From: Katherine Williams
Sent: 20 November 2025 16:53:46 UTC+00:00
To: "'Paul Burgess'" <paul.burgess@lewisplanning.co.uk>
Cc: "Junction Road Selfbuild" <junctionrd@yahoo.com>; "Giles Ings" <giles@abirarchitects.co.uk>
Subject: RE: DM/25/0961 - 201 Junction Road Burgess Hill

From: drainage <drainage@midsussex.gov.uk>
Sent: 31 October 2025 16:24
To: Katherine Williams <Katherine.Williams@midsussex.gov.uk>
Cc: drainage <drainage@midsussex.gov.uk>
Subject: 31/10/25 Re: DM/25/0961 - 201 Junction Road Burgess Hill West Sussex RH15 0NX
Importance: High

- Proposed Foul and Storm Water Drainage - DWG No & Rev: 100 P4
- Drainage Details - DWG No 7 Rev 201 P3
- Soakaway Calculations - dated Aug 2025 by Simon Dent Associates
- Infiltration Testing Summary - dated 10th October 2025 by Simon Dent Associates

07/04/2025 - Indicative Surface and Foul Water Drainage Proposal 0428.PL.302 rev A was submitted. A soakaway was proposed >20m's away from Networks rails boundary (red arrow)

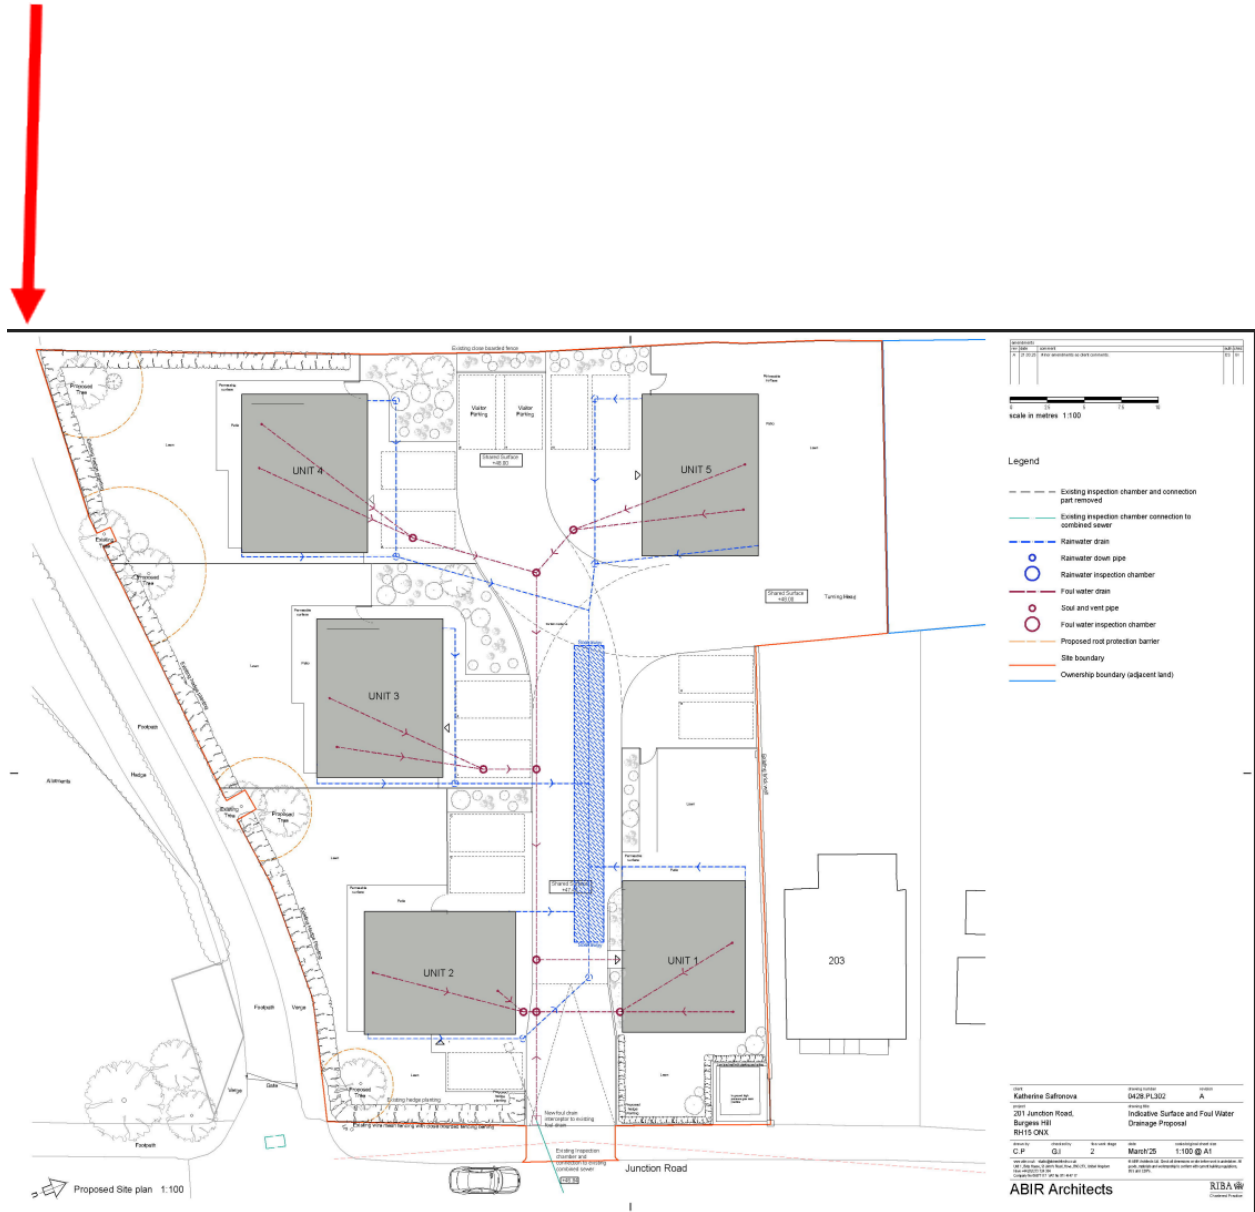
Network Rail should be reconsulted at this stage of the application, based on the design changes submitted.

While the applicant has demonstrated to the Flood Risk and Drainage Team with the latest drainage plan (26/08/25) that the site can be drained it does not comply to Network Rails Asset Protection requirements, therefore upon reconsult the applicant will need to redesign their strategy. All the key documents attached.
